Hi-Fi Audio	Quick Service Manual		Ref. No.: HA-97-195
			Date: Nov., 1997
	Model: SA-CH64/84/94 all series SA-AK70/90/75 all series SL-MC50/59/409/60 all series	Frequency: C	Cases reported (country) Panama

Subject: "Error" Indication in Disc Search

Hi-Fi Audio	Quick Service Manual		Ref. No.: HA-97-196
			Date: Nov., 1997
	Model: SA-CH64/84/94 all series SA-AK70/90/75 all series SL-MC50/59/409/60 all series	Frequency: C	Cases reported (country) U. K

Subject : Mechanism jamming problem

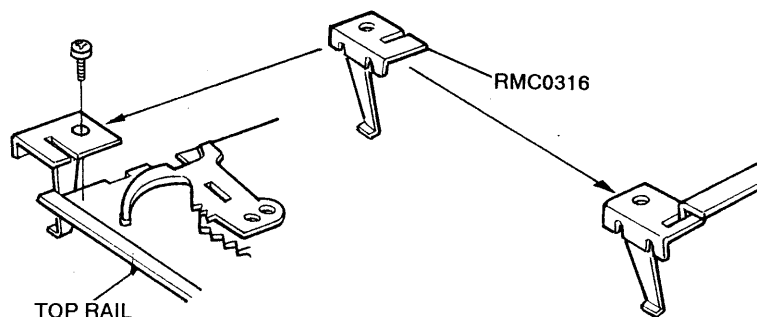
Symptom: "Error" Indication after Disc Search mode.

Cause: The teeth of slide gear is shifted due to vibration or/and shock in transportation.

Remedy: 1) Add lock plate spring (RME0025) on loading mecha motor.

2) Add Balance spring (RMC0316) on top rail.

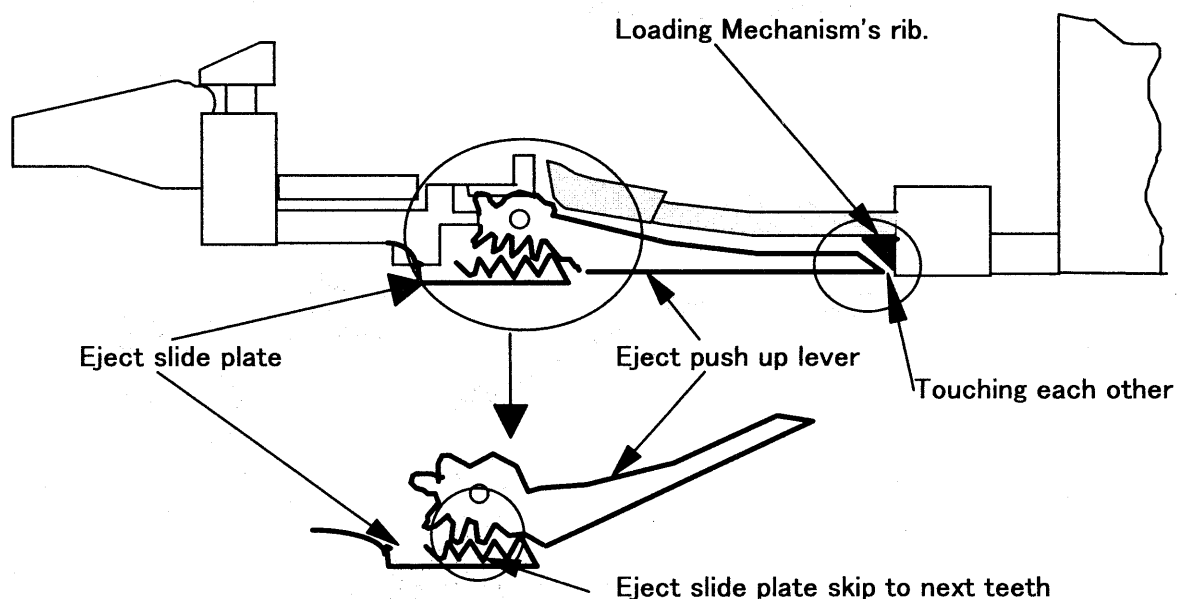
Symptom : Traverse Loading Mechanism doesn't move at all.

Cause : According to our investigation result, This is for only one situation such as below.

- 1) When the Eject Lever was pressed, while eject Lever position was same number with play position (example : 10 slot), it will touch to Loading Mechanism's rib.
- 2) Then if the Eject Lever was pressed more strongly, The gear of Eject slide plate will be skip to next teeth.
- 3) Usually the Eject side lever will be go back to initial position by spring, but in this case it doesn't go back to initial position for gear sticky. So Eject Lever will stay upper position.
As a result, Loading Mechanism movement is disturbed.

- 1) Change eject push up lever Ass'y from old type (RFKNLMC50PEK) to new type (RFKNCH64MP-K).
- 2) Change eject slide plate from old type (RML0439) to new type (RML0439-1)

< Improvement Point >

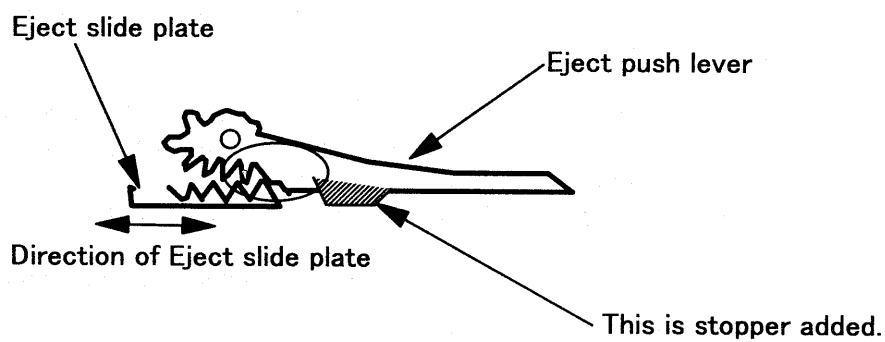
1) Eject push lever add material. (change shape)

2) Eject slide plate
